**MICROCHIP****PIC18F2420/2520/4420/4520****PIC18F2420/2520/4420/4520 Rev. B3 Silicon Errata**

The PIC18F2420/2520/4420/4520 Rev. B3 parts you have received conform functionally to the Device Data Sheet (DS39631E), except for the anomalies described below. Any Data Sheet Clarification issues related to the PIC18F2420/2520/4420/4520 will be reported in a separate Data Sheet errata. Please check the Microchip web site for any existing issues.

The following silicon errata apply only to PIC18F2420/2520/4420/4520 devices with these Device/Revision IDs:

FIGURE 1: SCK PULSE VARIATION USING TIMER2/2**Work around**

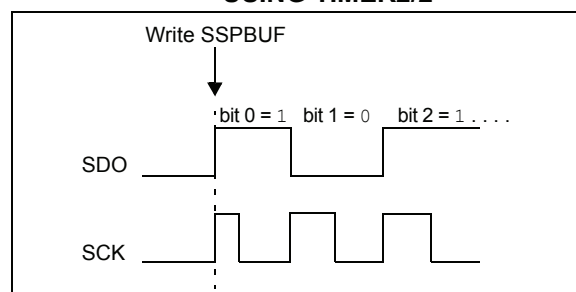
When the SPI is using Timer2/2 as the clock source, a shorter than expected SCK pulse may occur on the first bit of the transmitted/received data (Figure 1).

To avoid producing the short pulse, turn off Timer2 and clear the TMR2 register, load the SSPBUF with the data to transmit and then turn Timer2 back on. Refer to Example 1 for sample code.
